Access Compliance Report Public Rights-of-Way (Pedestrian Signals)

Main Street: N/A Cross Street: ANTONIO_PKWY Location: NW

ADA ID: SGRK211202130804 Signal Type: One Push Button-Non APS Overall Compliance: No Severity Scores: BTN 1: 35 BTN 2: N/A No BTN: N/A

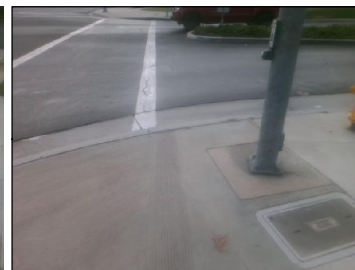
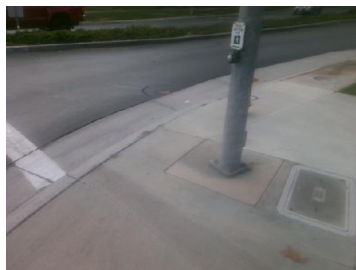
Possible Solutions: Replace Signal Push Button With APS Button. Remove and Replace Clear Space.

OC Std/PROW: R404.2, R404.3, MUTCD 4e.08
